■ ECO <input type="checkbox"/> ECR	NO. <b>4026</b>	EFF DATE OF CHG <b>2/22/94</b>	REQUESTED BY J. JONES	PREMIER	PAGE <u>1</u> OF <u>3</u>
<b>REASON FOR CHANGE</b>		DOCUMENTS EFFECTED 206-AA-1002		SYSTEM INSTALL, MOUNTING PROVISIONS, BELLY	MATL DISPOSITION
DRAWING IMPROVEMENT				REWORK	STORE <input type="checkbox"/> IN MFG.
MARKED PRINTS ATTACHED YES <input type="checkbox"/> NO <input checked="" type="checkbox"/>				SERIAL NO EFF 206 SERIES	SCRAP <input type="checkbox"/> USE AS IS <input type="checkbox"/>

THIS IS AN UNINCORPORATED  
ECO  
(STC SH3763SW)

ECO ■ 4026

"CHANGED" PARTS LIST ZONE 4B

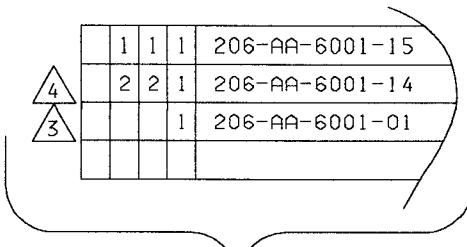
"WAS"

"IS"

## "CHANGED" SECTION B-B ZONE 2C

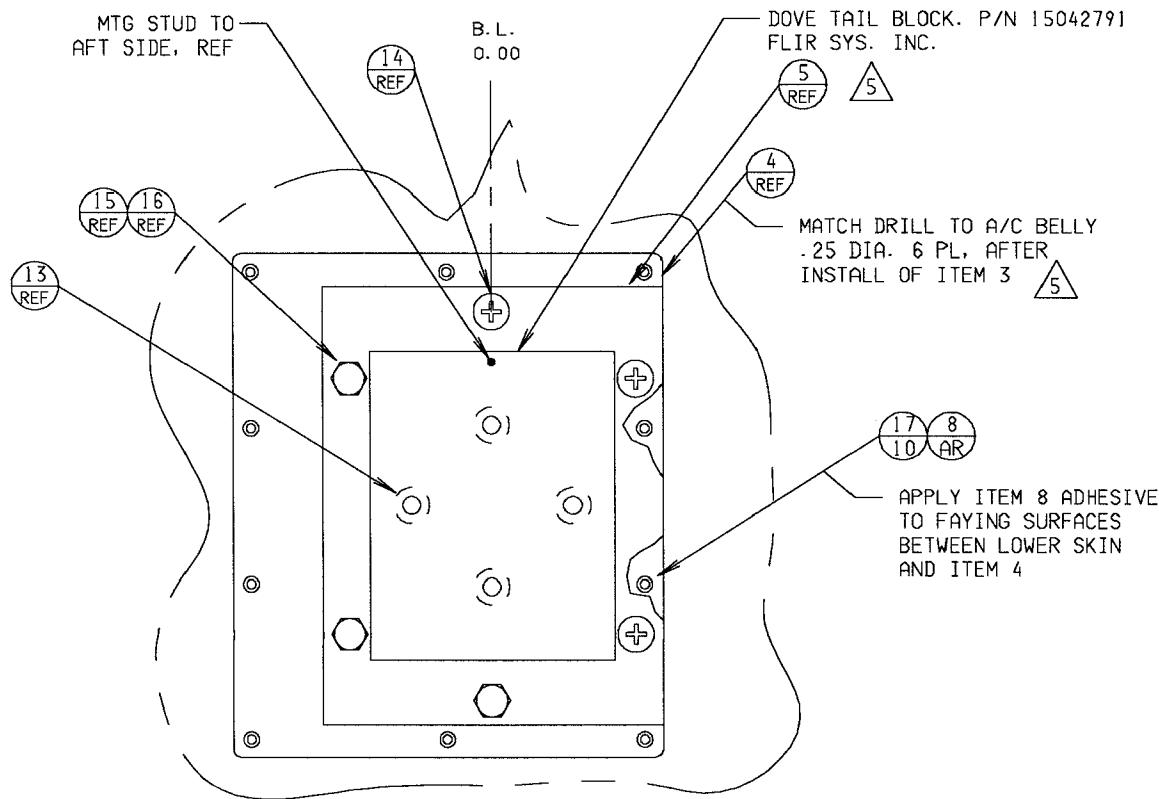
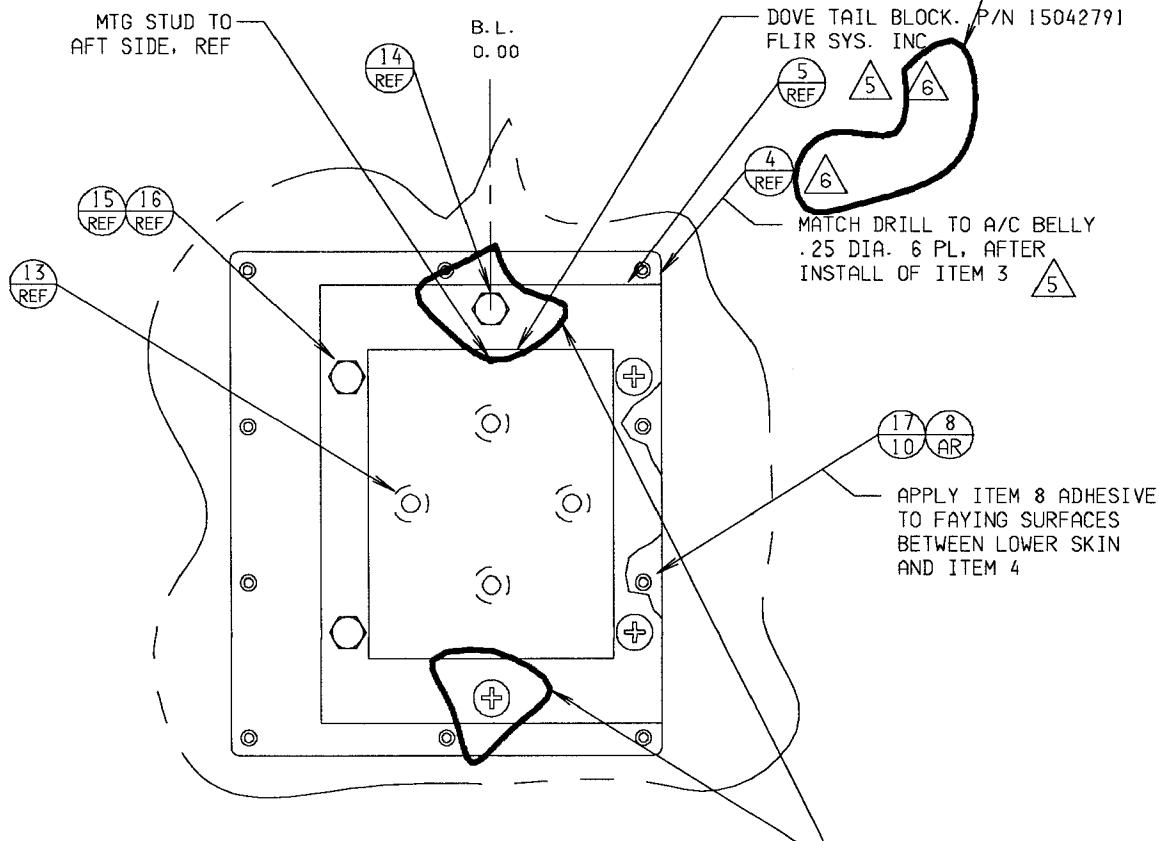
## SHEET 1A CONTINUED

"WAS"

## "CHANGED" SECTION B-B ZONE 2C

"IS"
